The City of Spartanburg Design Review Board

AGENDA

March 4, 2025, at 5:30 P.M.

189 W. Main Street/Hotel & Office/ 7-12-20-030.00

VARIANCE REQUESTS: Streetscape Width - Revisions

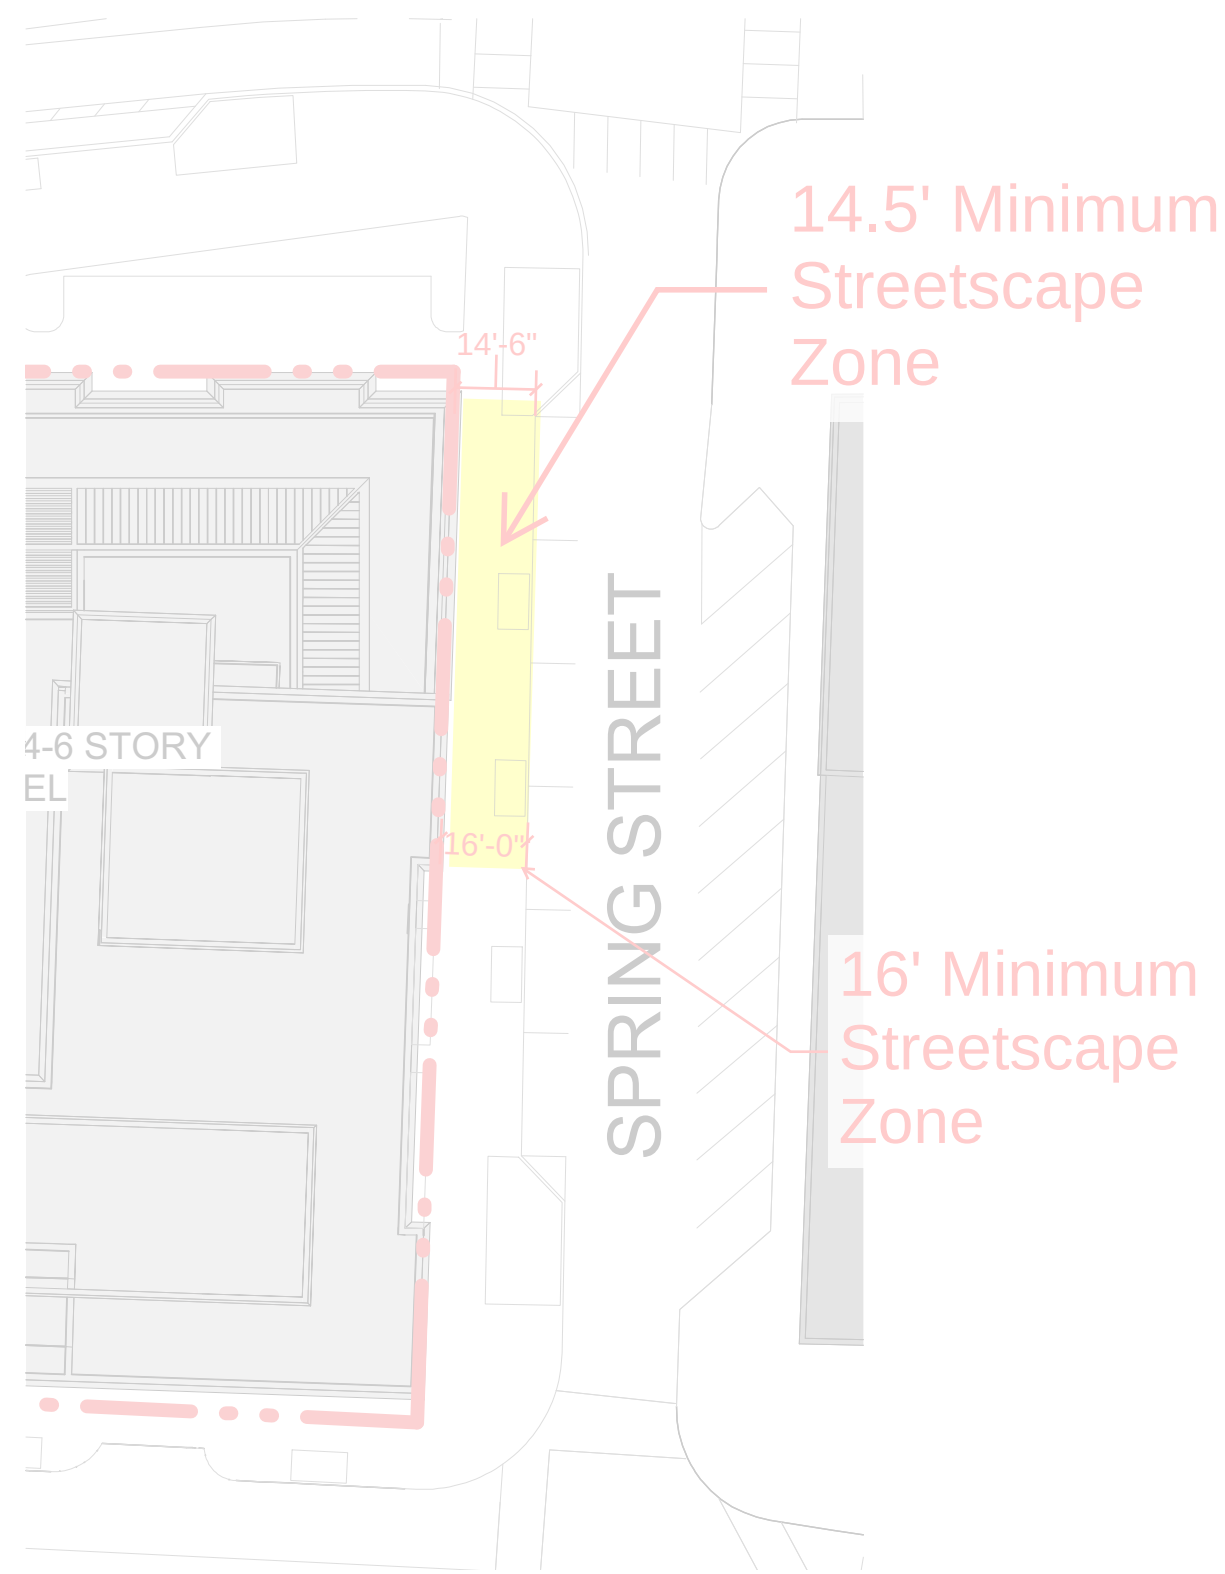
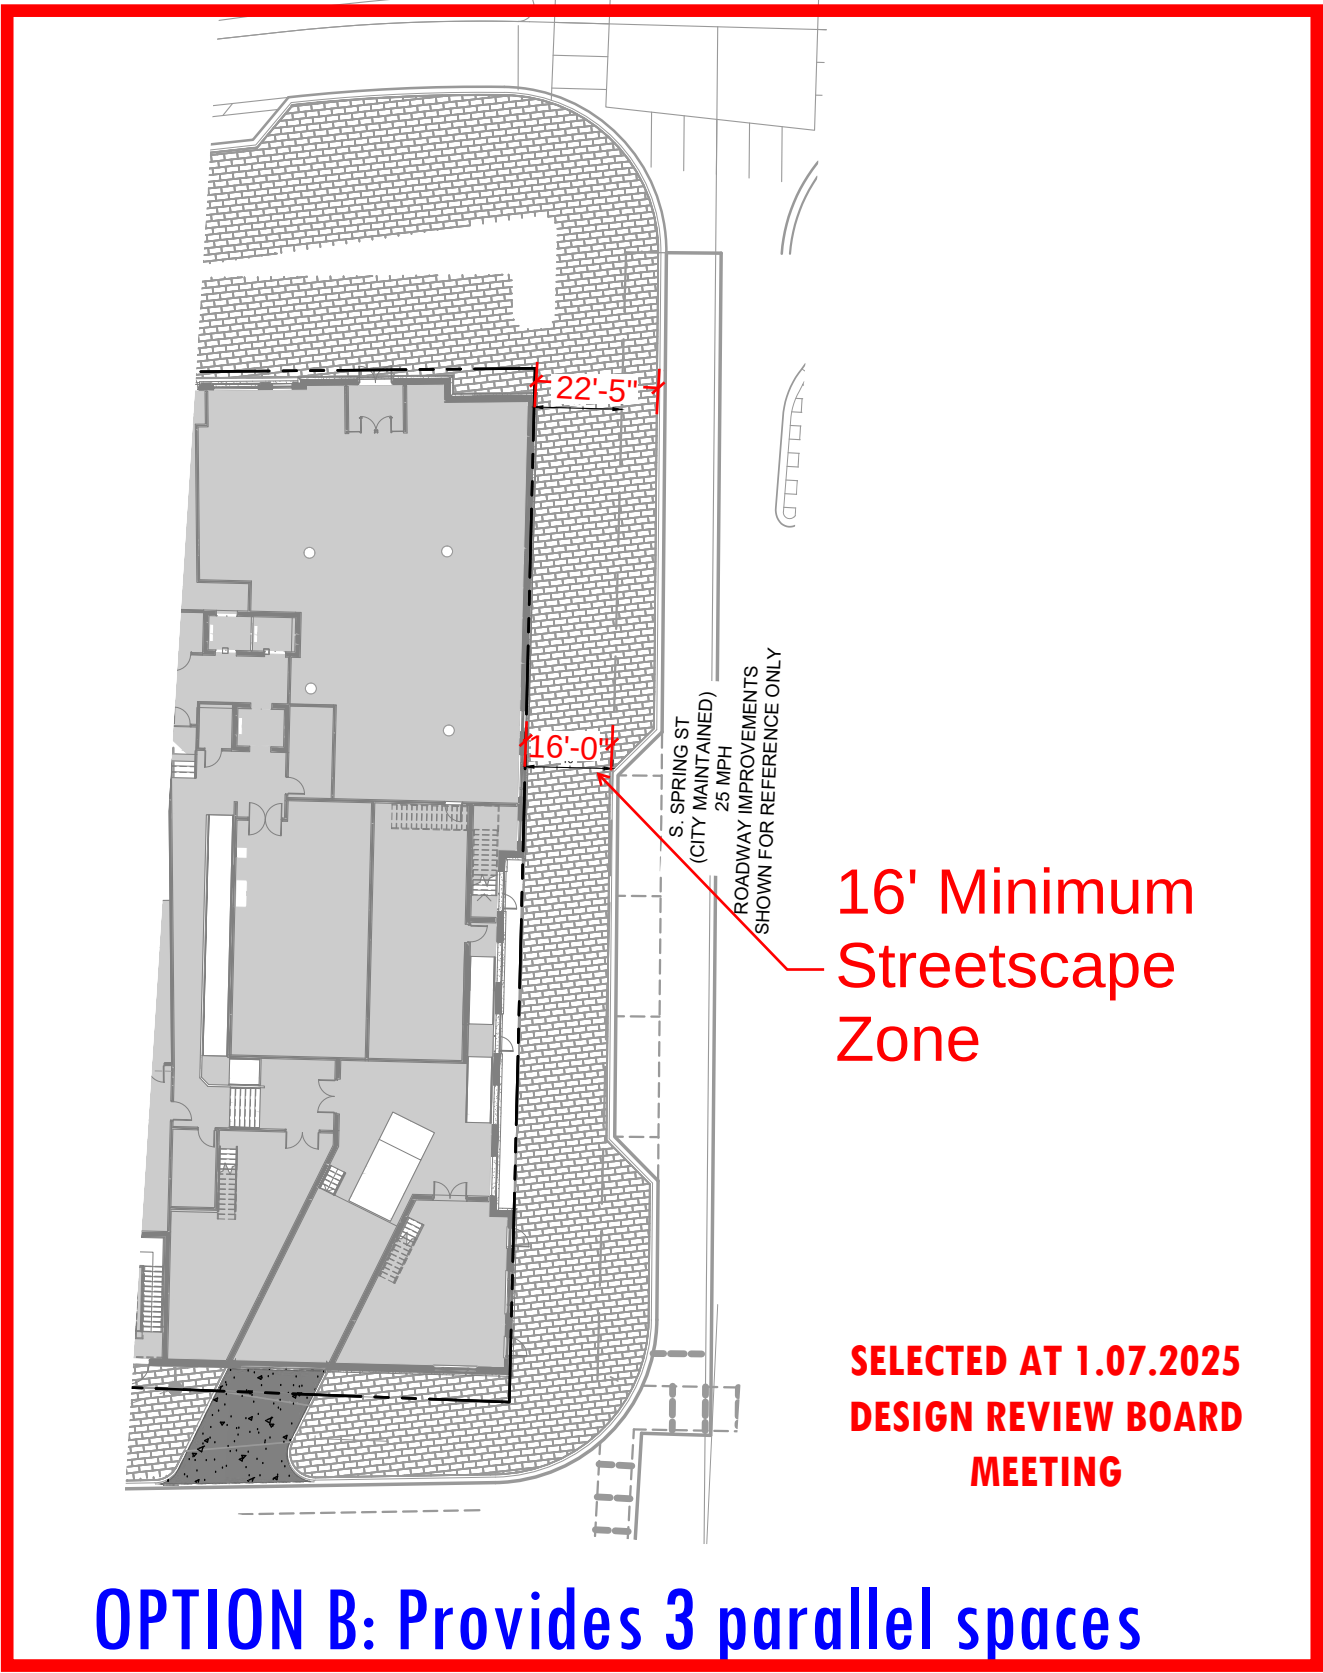
To permit a sidewalk zone along Spring Street that is less than 16 feet in total width (shown as 14 ft 6 in between the retaining wall and the edge of curb) and sidewalk that is less than 8 feet in total width (6 ft 3 in).

DRB Recommendation – Conditional Support.
The Board supports the Applicant’s streetscape Option B response to the previously submitted noncompliant streetscapes along Spring Street and West Broad Street. Option B reduces the proposed six parallel parking spaces along Spring Street to three spaces and provides a pedestrian environment more closely aligned with the streetscape standard. The Applicant is requested to update the plans to reflect the three-space parallel parking option.

Along W Main, S Daniel Morgan and the predominate portion of S Spring Street, the proposed development meets or exceeds the minimum 16 feet streetscape zone width requirement of the DT-6 zoning. At Broad Street, which serves as a transition between the DT-5 (south side) and DT-6 (north side) zoning districts, we have proposed a streetscape zone width of a minimum of 12 feet. This is an increase of the existing 8 feet width and is consistent with the dimension of the streetscape zone of Broad Street blocks to the east of Spring Street, which vary between +/-10 and 15 feet in width. The 12 feet dimension would provide a consistent streetscape zone on the both side of Broad Street and meet or exceed the required minimum of the DT-5 zone. At S Spring Street, the proposed building is parallel to the existing building on the east side of the street; however the existing street alignment is slightly skewed to both properties, creating a varied streetscape zone along the northern +/- 80' of the development, with the northernmost corner of the project 14.5 feet from the back of the curb. We have located tree wells to maximize the pedestrian path in this area.

1. Revision of curb line along Spring Street to remove three parking spaces and provide for a streetscape and sidewalk that meets the requirements of DT-6 zoning (per Option B selected by the Board at the 01.04.2025 preliminary review meeting)

OPTION B: Provides 3 parallel spaces

SELECTED AT 1.07.2025
DESIGN REVIEW BOARD
MEETING

CIVIL SITE PLAN - Revisions

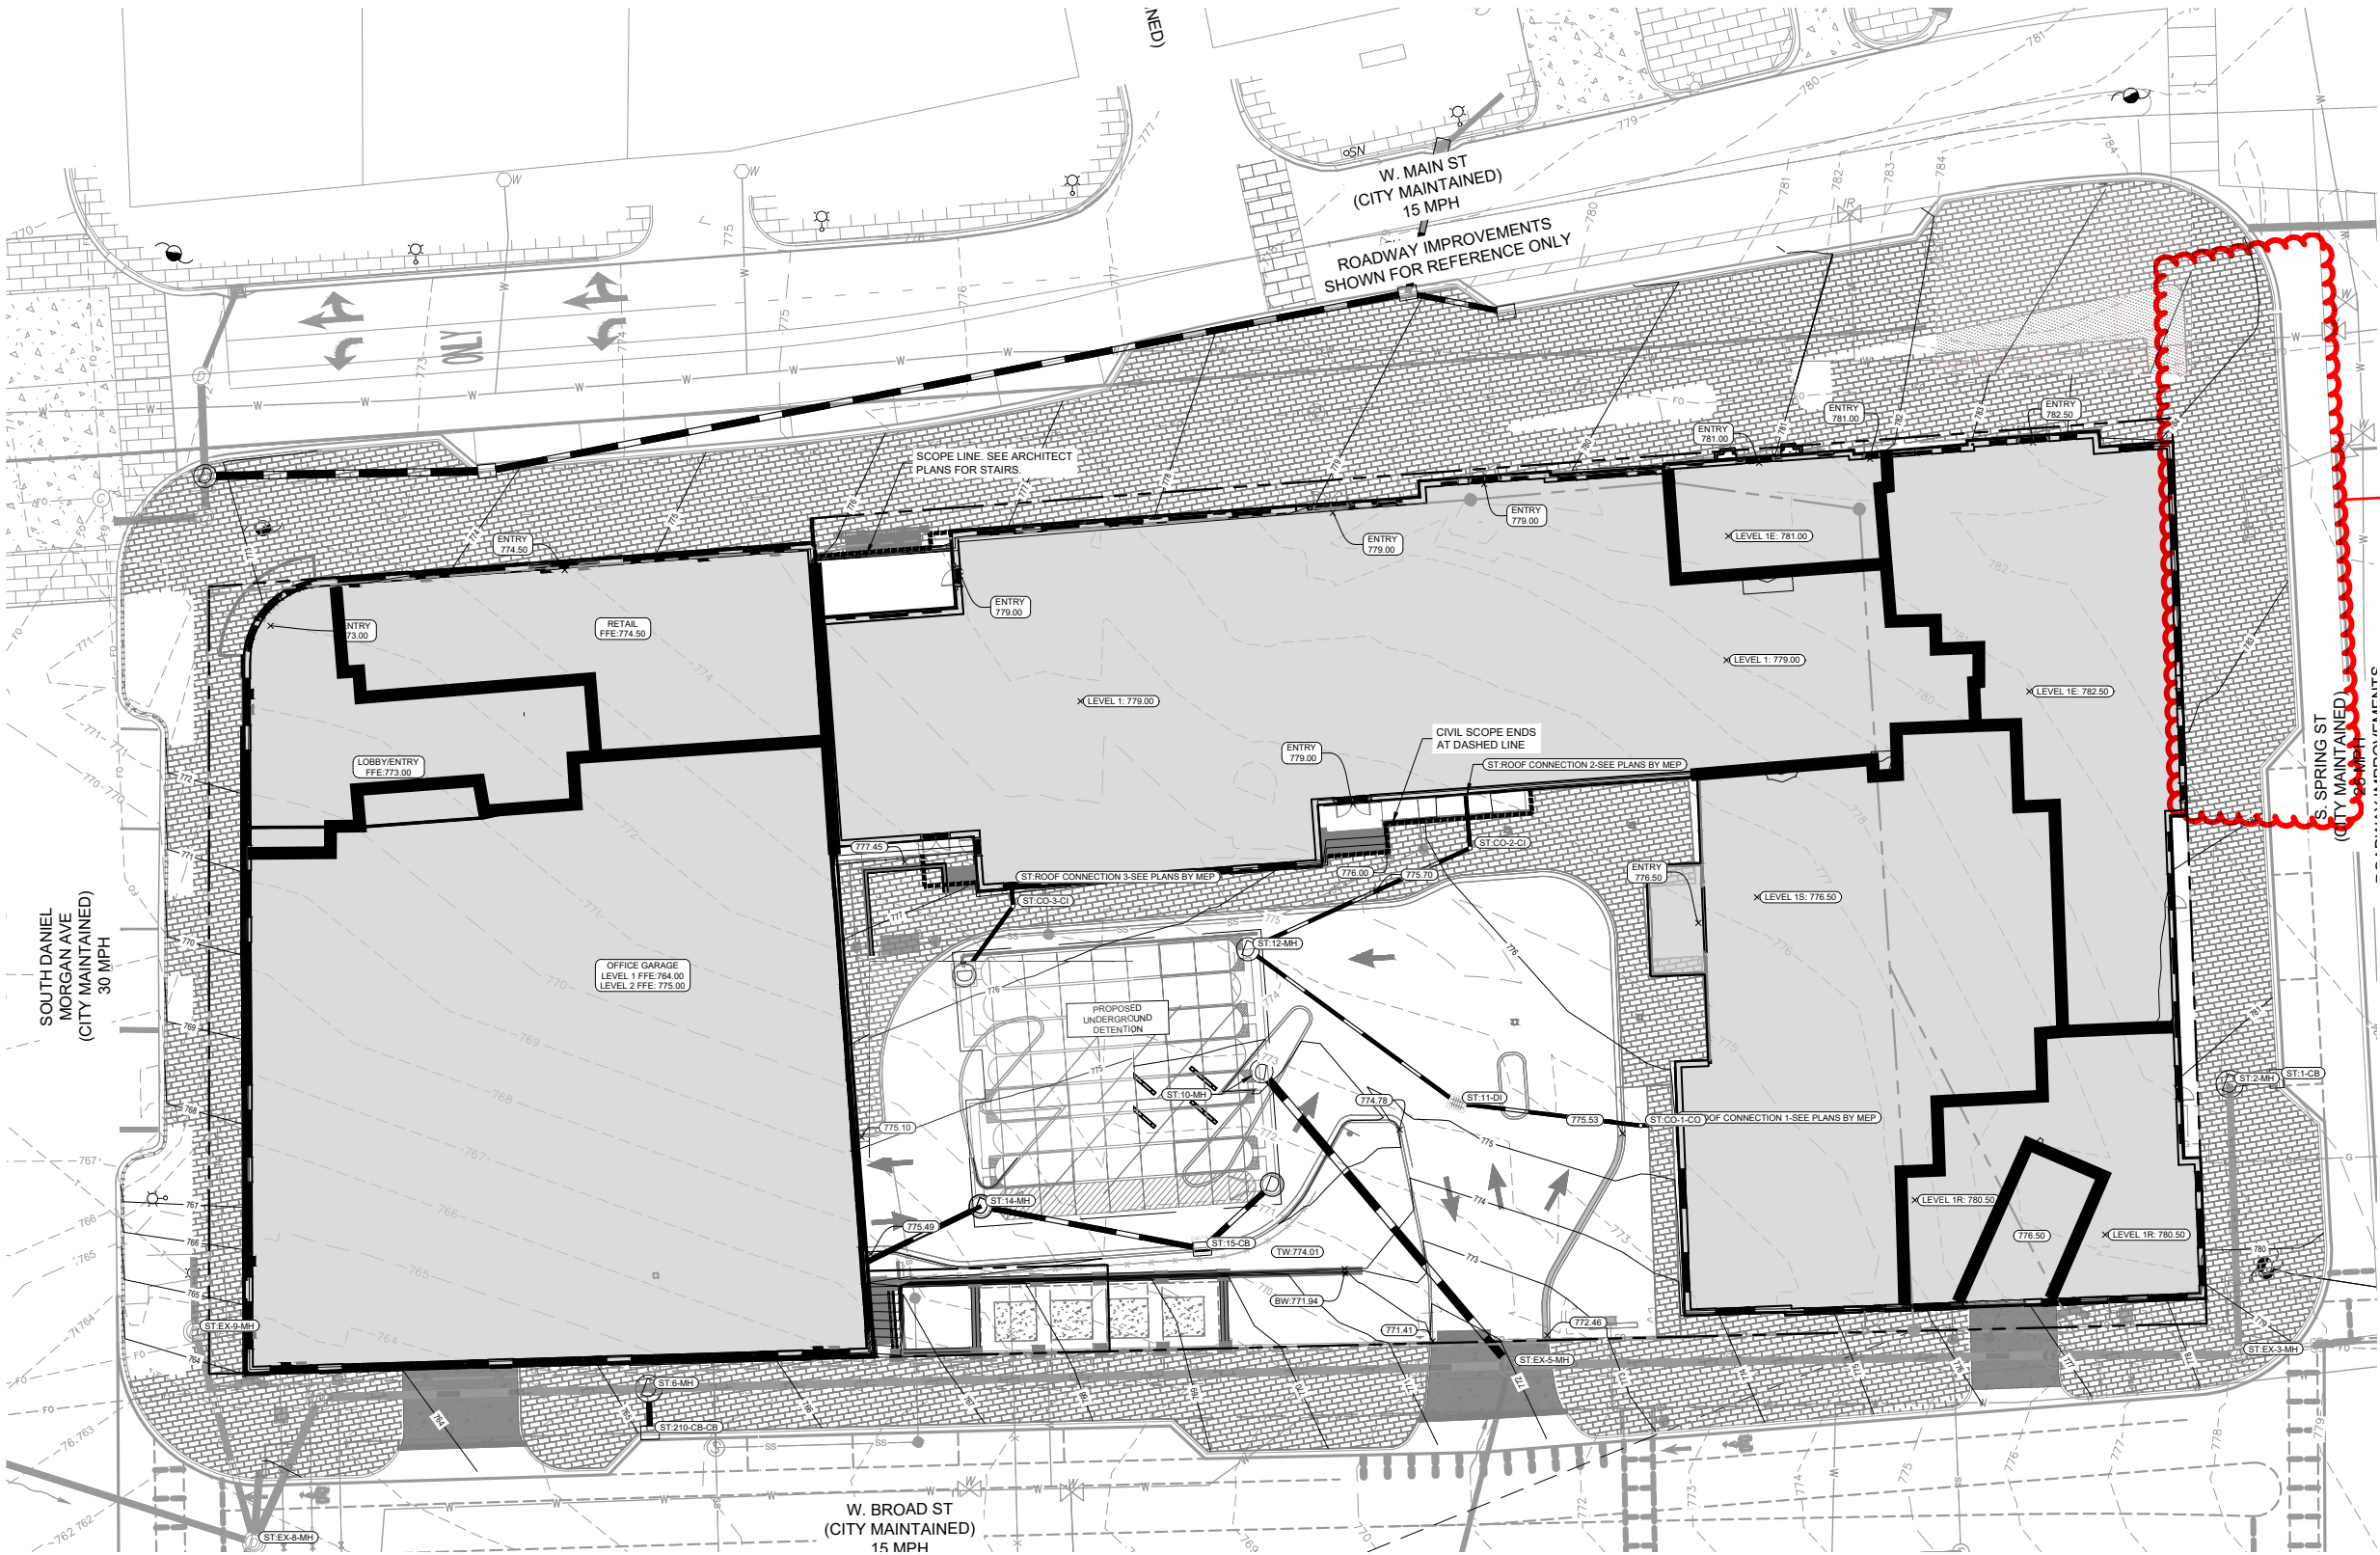
PARKING AND
STREETSCAPE
WIDTH REVISED PER
BOARD REQUEST.
MEETS DT-6
REQUIREMENTS

NORTH ELEVATION - EAST END
SCALE: 3/64" = 1'-0"

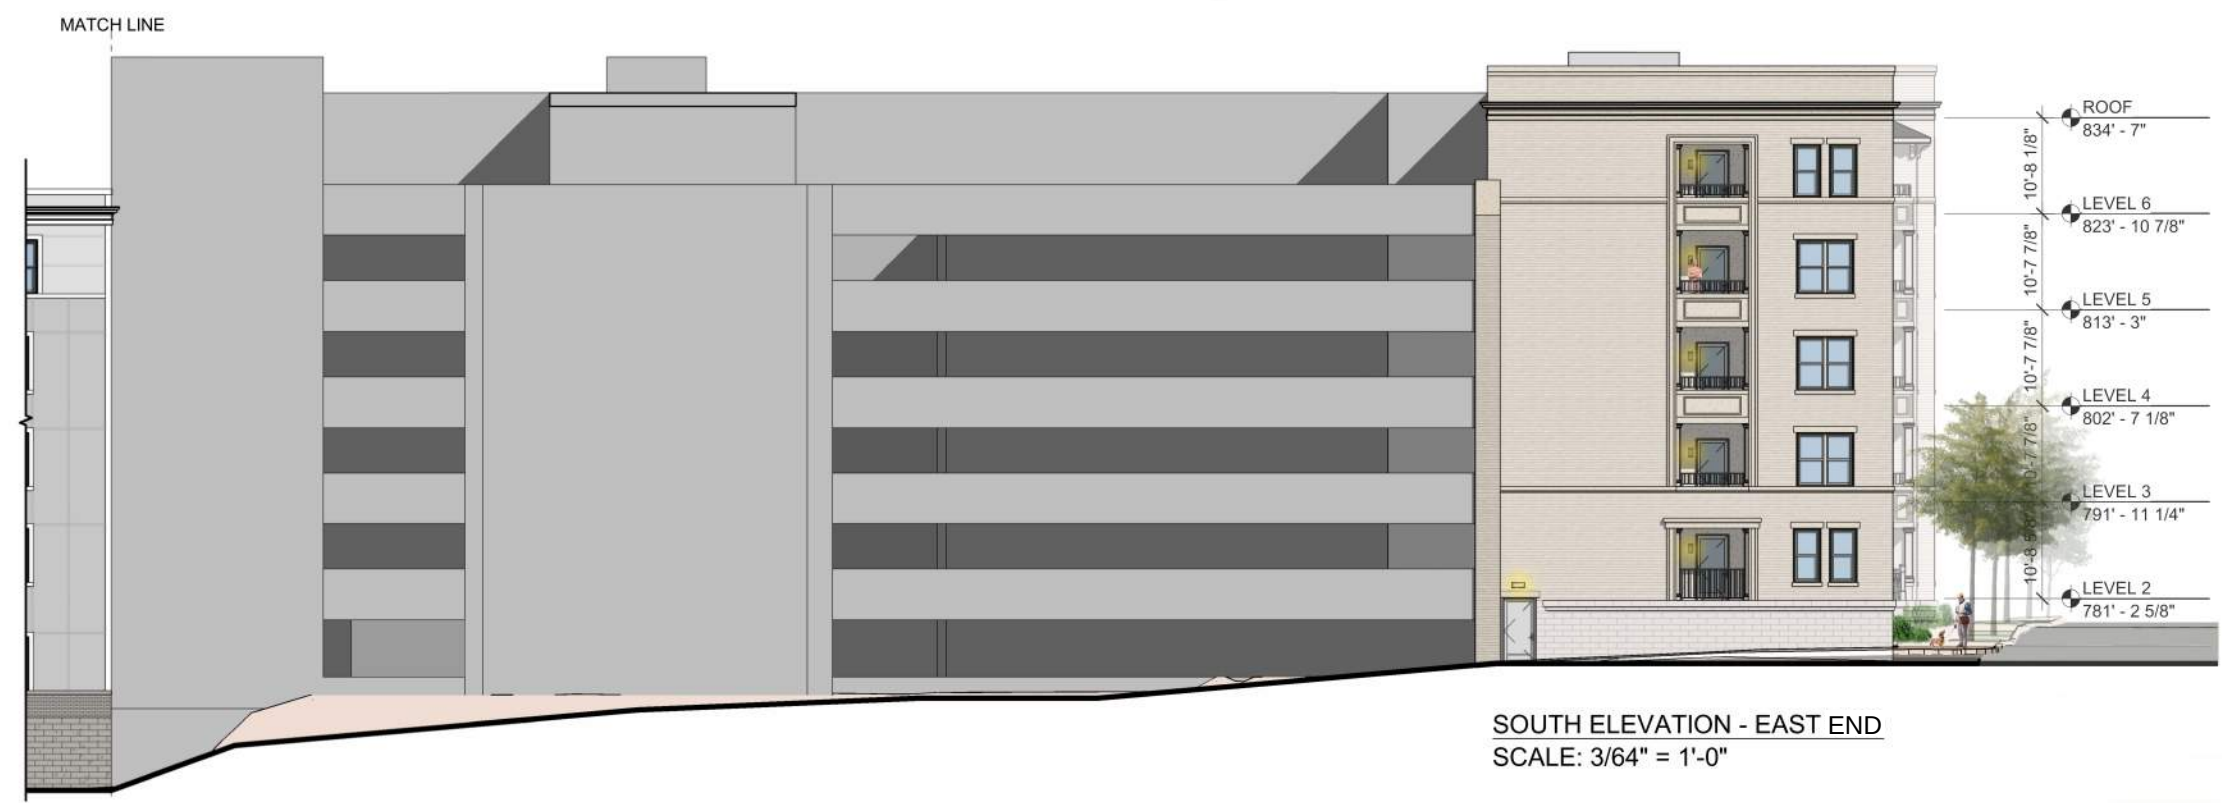
- **6.4.3 Encroachments:** *Compliant*
 - **6.4.4 Ground Level Detailing:** 60% Glazing in Transparency. *Please provide dimensions to the facades to be able to calculate the frontage transparency. Exception required for elevations along Daniel Morgan Avenue, Broad Street, and Spring Street.*

2. Ground Level Detailing:
 - a. Spring Street at Hotel: Ownership has confirmed that the artwork as shown in the elevations and renderings will be a permanent installation on a metal substrate panel. This allows the flexibility to replace a panel if one is damaged.
